**RE: Response to Disapproval  
Rail Car Loading Area Release Soil Sampling Investigation Work Plan  
Western Refining Southwest LLC, Gallup Refinery  
EPA ID #NMD000333211  
HWB-WRG-21-001**

**New Mexico Environment Department to Marathon Petroleum Company Comment Letter “Response to Disapproval Rail Car Area Release Soil Sampling Investigation Work Plan” (March 4, 2021)**

**REVISED RAIL CAR LOADING AREA RELEASE SOIL  
SAMPLING INVESTIGATION WORK PLAN**

**2 PROPOSED SAMPLE LOCATIONS**  
SCALE: 1" = 60'

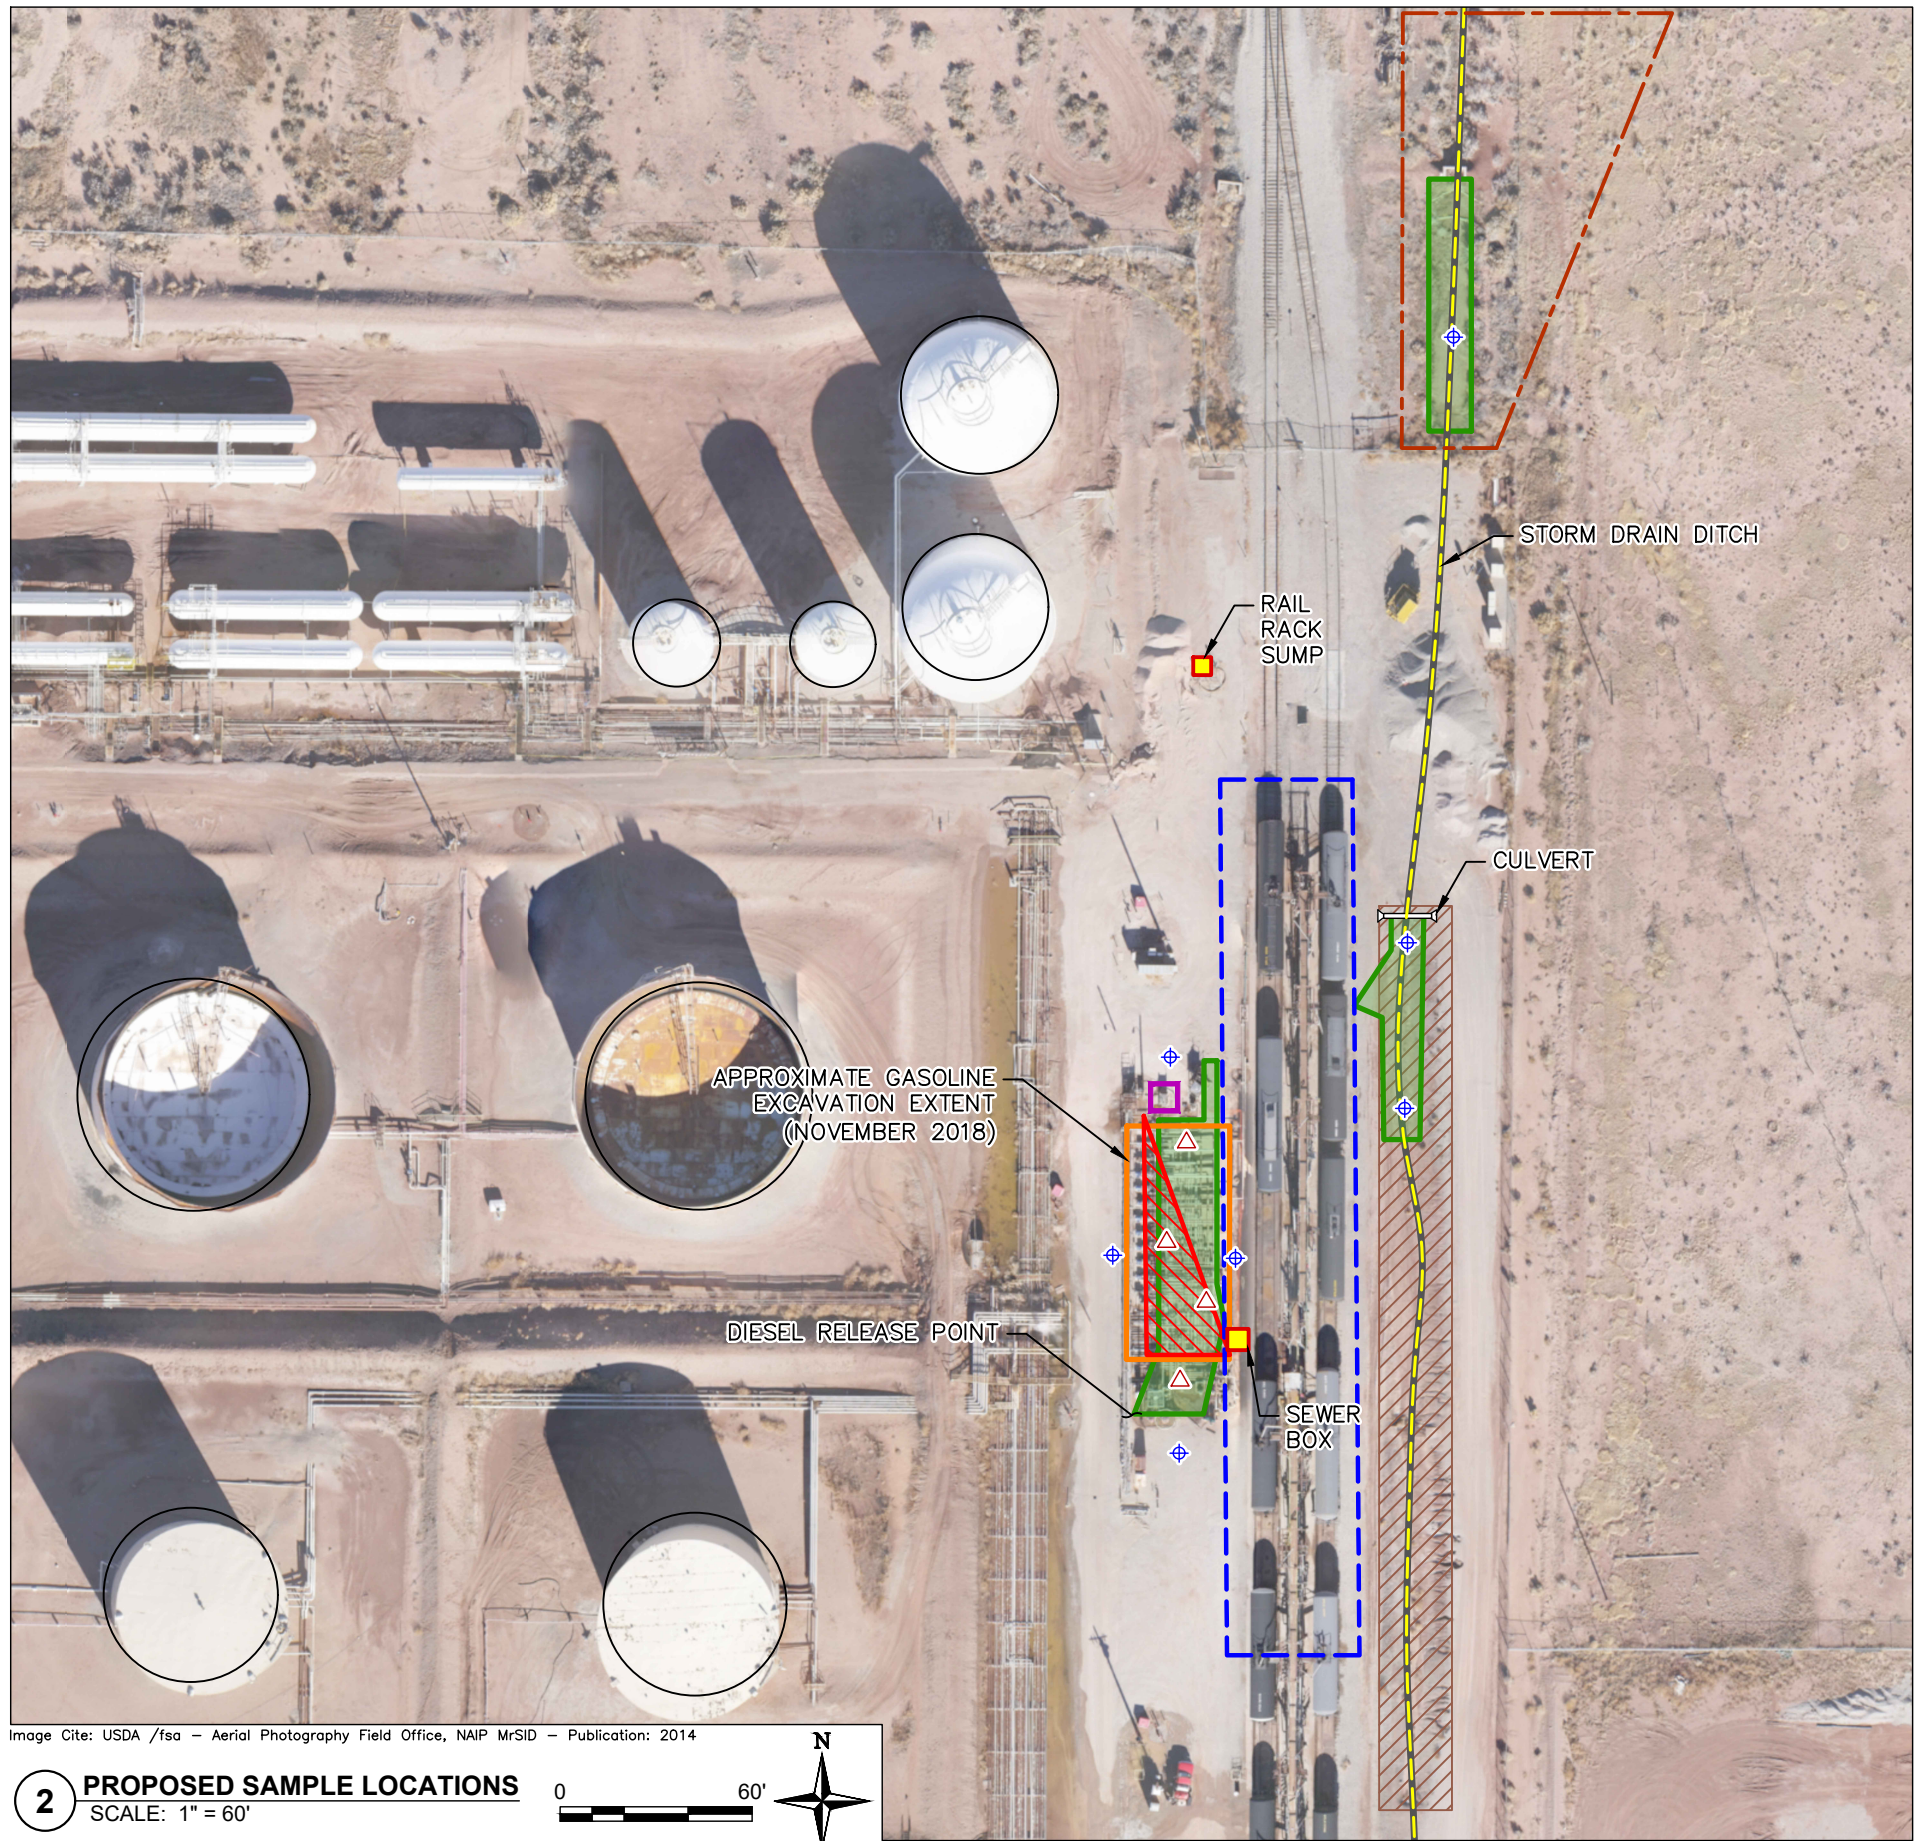
New Mexico Environment Department (NMED) Comments	Marathon Petroleum Company (MPC) Response
<b>Comment 1:</b>	<b>Response 1:</b>
<p>In the Executive Summary, page 3 of 10, the Permittee states, “[d]iesel leaked across the railroad tracks into a culvert carrying product into the stormwater system.” Figure 2, <i>Proposed Sample Locations</i>, does not depict the location of the culvert and the stormwater system. Present the location of the culvert and the stormwater system in a revised figure. In addition, it is necessary to collect soil samples from the stormwater collection ditch where native soils are exposed immediately downstream of the culvert in order to verify whether the diesel release affected the soils in the ditch, if applicable. Revise the Work Plan accordingly.</p>	<p>In response to NMED’s Comment 1, Figure 2 has been revised to present the location of the culvert and the stormwater collection ditch.</p> <p>The Executive Summary, page 3 of 10, has been revised to state, “[i]n addition, the Investigation Work Plan proposes collection of soil samples from the stormwater collection ditch and northern boundary of the diesel release to verify if soils have been affected.” The Work Plan has also been revised in the Scope of Activities Section, page 6 of 10, to state, “[s]oil samples will be collected at the following locations:</p> <ul style="list-style-type: none"> <li>• Four locations within the gasoline release excavated area</li> <li>• Five to eight locations at the stormwater collection ditch and northern boundary of the diesel release. The total number and location of borings will be based on visual observations (e.g., discolored soil, stressed vegetation, low topography). The stormwater collection ditch will be sampled where native soils were exposed, downstream of the culvert . The northern boundary samples will be collected to verify whether the area was affected and if released diesel could have potentially accumulated in topographically low areas.</li> </ul> <p>Samples will be collected with a hand trowel and/or a hand auger, at 6-inches bgs and 1-ft bgs. The number of collected soil samples at the ditch and northern boundary will be dependent on visual impacts and indicators.”</p>

New Mexico Environment Department (NMED) Comments	Marathon Petroleum Company (MPC) Response
<b>Comment 2:</b>	<b>Response 2:</b>
<p>In the Background Section, page 5 of 10, the Permittee states, “[o]n March 13, 2019, an estimated 1,765 gallons of diesel were released in the same area. Of the 42 barrels (1,765 gallons) released, approximately 40 barrels (1,680 gallons) were recovered via vacuum truck. Approximate locations of both releases are shown in Figure 2.” Figure 2 shows three non-contiguous affected areas where the extent of the diesel release is estimated. It is not clear how the diesel spread into three non-contiguous areas. Provide an explanation in the revised Work Plan. In addition, one of areas affected by the release is shown 2,000 feet northeast of the rail loading rack sump in Figure 2; however, the northern boundary of the area is not defined. Revise the figure to depict the northern boundary of the release. Furthermore, it is necessary to collect soil samples in the vicinity of the northern boundary to verify whether the diesel release affected the area. The soil samples must be collected in topographically low areas where the released diesel could potentially accumulate. Revise the Work Plan accordingly.</p>	<p>In response to NMED’s Comment 2 on how the diesel spread into three non-contiguous areas, the Background Section, pages 5 of 10 and 6 of 10, has been revised to state, “The diesel release began due to a valve and/or union connection failure on hard piping at the diesel filter pot and spread to the northeast (Figure 2). The diesel then migrated north via the storm water ditch; the non-contiguous locations are due to the pathway of the ditch.” Of the 42 barrels (1,765 gallons) released, approximately 40 barrels (1,680 gallons) were recovered via vacuum truck. Approximate locations of both releases are shown in Figure 2.</p> <p>The purpose of this Investigation Work Plan is to collect soil confirmation samples to determine the extent of contamination. The sample results will guide the need for any further investigation. If the analytical results indicate that additional investigation is required, MPC will prepare a work plan to extend the investigation area. Based on the results, MPC will review options for potential remediation, as necessary.”</p> <p>Figure 2 has been updated to show the northeastern extent of the diesel release.</p> <p>In response to the collection of soil samples, the Work Plan has been revised in the Executive Summary, page 3 of 10, to state, “[i]n addition, the Investigation Work Plan proposes collection of soil samples from the stormwater collection ditch and northern boundary of the diesel release to verify if soils have been affected” and in the Scope of Activities Section, page 6 of 10, to state, “[s]oil samples will be collected at the following locations:</p> <ul style="list-style-type: none"> <li>• Four locations within the gasoline release excavated area</li> <li>• Five to eight locations at the stormwater collection ditch and northern boundary of the diesel release. The total number and location of borings will be based on visual observations (e.g.,</li> </ul>

New Mexico Environment Department (NMED) Comments	Marathon Petroleum Company (MPC) Response
	<p>discolored soil, stressed vegetation, low topography). The stormwater collection ditch will be sampled where native soils were exposed, downstream of the culvert. The northern boundary samples will be collected to verify whether the area was affected and if released diesel could have potentially accumulated in topographically low areas.</p> <p>Samples will be collected with a hand trowel and/or a hand auger, at 6-inches bgs and 1-ft bgs. The number of collected soil samples at the ditch and northern boundary will be dependent on visual impacts and indicators.”</p>
New Mexico Environment Department (NMED) Comment	Marathon Petroleum Company (MPC) Response

Comment 3:	Response 3:
<p>In the Scope of Activities Section, page 6 of 10, the Permittee states, “[s]oil samples will be collected at four locations within the gasoline release excavated area with a hand trowel and/or a hand auger, at 6-inches bgs and 1-ft bgs. In addition, soil borings will be completed with a Geoprobe at seven locations outside of the bermed area to 8 ft bgs.” Figure 2 shows the extent of the gasoline release; however, it is not clear whether the excavated area overlaps with the extent of the gasoline release. Provide a clarification in the revised Work Plan. If the extent of the gasoline release is not consistent with the excavated area, Figure 2 must be revised to present the excavated area. In addition, the location of the berms presumably overlaps with the boundary of each diesel release extent; however, it is not clear from Figure 2. Present the location of the berms in the revised figure. Furthermore, provide information regarding the maximum depth of the excavation in the revised Work Plan. If the maximum depth of the excavation exceeded eight feet below ground surface (bgs), propose to advance the soil borings to the equivalent maximum depth outside of the bermed area. Revise the Work Plan, where applicable.</p>	<p>In response to NMED’s Comment 3, Figure 2 has been revised to show the extent of the gasoline release excavation and the location of the berms. The excavation extent overlaps with the gasoline release extent. The Work Plan has been revised in the Background Section, page 5 of 10, to state, “[t]he area excavated covered the extent of the gasoline release.”</p> <p>Information regarding the maximum depth of the excavation is located in the Background Section, page 5 of 10, and has been updated to state, “[i]n November 2018, approximately 153 tons of petroleum-impacted soils beneath the pipe rack were excavated to a depth of 18-inches below ground surface (bgs) in an area approximately 41 feet by 97 feet (Figure 2).”</p> <p>The maximum depth of the excavation did not exceed eight ft bgs.</p>
